PLANNING, ZONING, & BUILDING DEPARTMENT
PZ&B Staff Combination Memorandum: Architectural Commission and Town Council

SUBJECT: ARC-24-015 (ZON-24-025) 153 AUSTRALIAN AVE (COMBO)

MEETING: APRIL 24, 2024 ARCOM
MAY 15, 2024 TOWN COUNCIL

CURRENTLY PROPOSED SOUTH ELEVATION

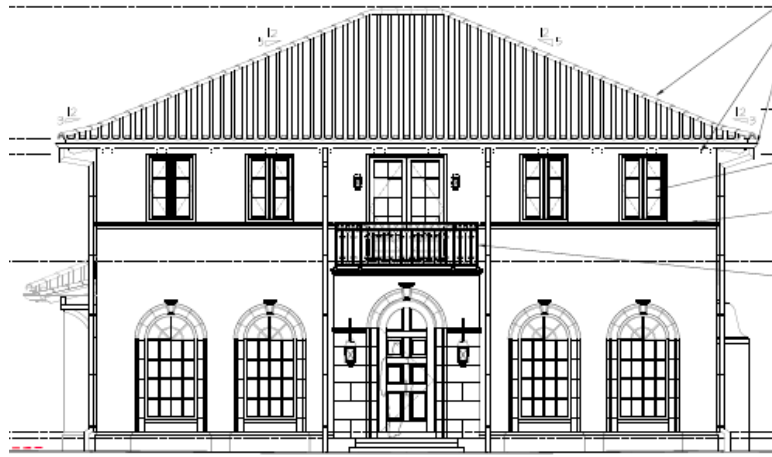
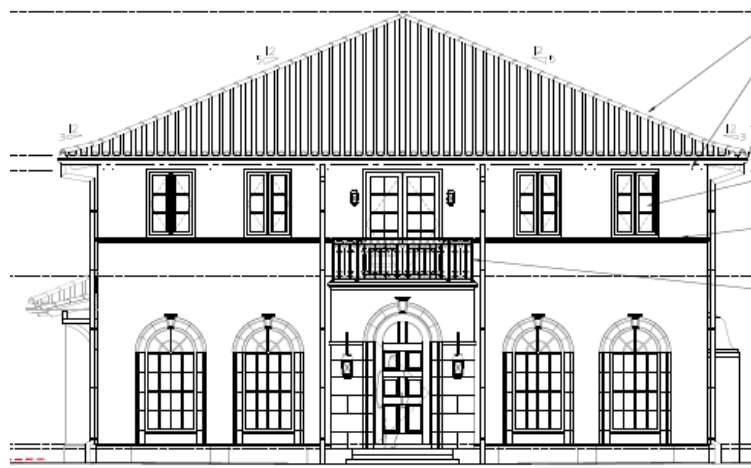
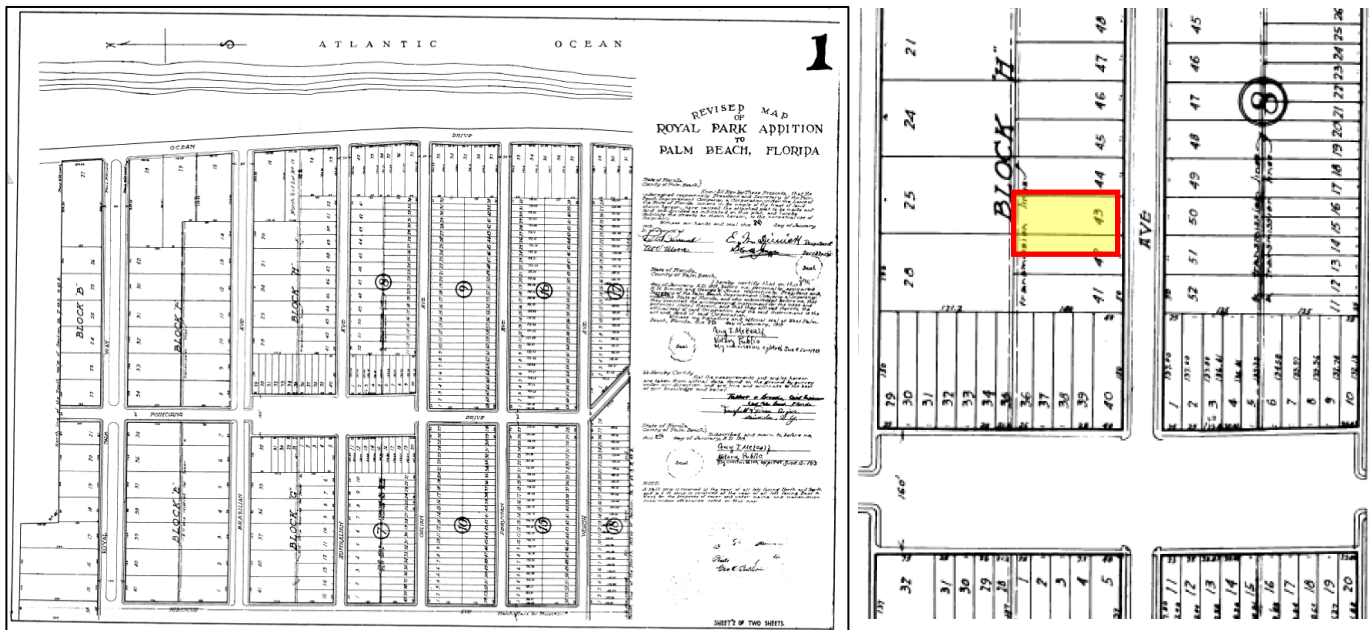
At the FEBRUARY 28, 2024 ARCOM meeting, the Commission deferred (7-0) the project with comments to restudy architectural details, massing, roof plan, and landscape plantings. Additionally, a motion was made and approved (7-0) that the implementation of the proposed variances would not negatively affect the architecture.

The project was deferred at the MARCH 27, 2024 meeting for further refinement of architectural details.

The applicant has resubmitted plans in response to comments of the commission. Changes include relocation of the belt course to the second floor sill, and modification of the entire roof, including elimination of previously proposed dormer windows. An alternate roof design is also included in the presentation.
